RE Bendigo-Ophir Gold Project Air Quality Assessment Addendum: Cement and Concrete Batching

This short memo responds to ORC Request #1, which reads:

Figure 1: BOGP site diagram, highlighting cement and concrete plant location.

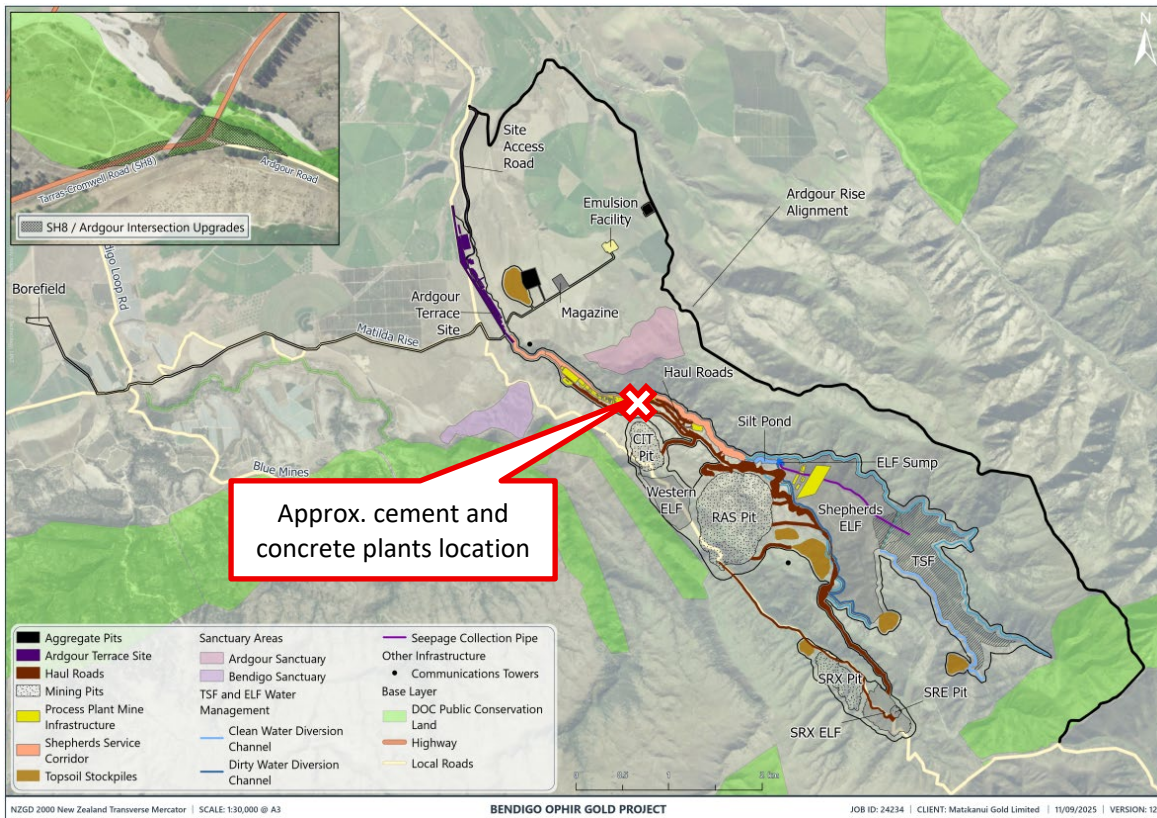
Please provide an air quality assessment, prepared by a suitably qualified and experienced air quality specialist, for:

- a. *The concrete batching plant*
- b. *The cement paste plant*

The location of the proposed BOGP cement paste and concrete batching plants is within Shepherds Valley, alongside the heavy vehicle workshop and near to the gold processing plant, as illustrated at Figure 1, adapted from Fast Track Document Number C.02.

At BOGP, the nearest sensitive receptors are separated from the proposed BOGP cement and concrete plants by an order of magnitude greater than these typical distances and those recommended by separation distance guidance. Given this separation, there is no credible pathway for any potential dust discharges from the cement and concrete activities to impact these receptors.
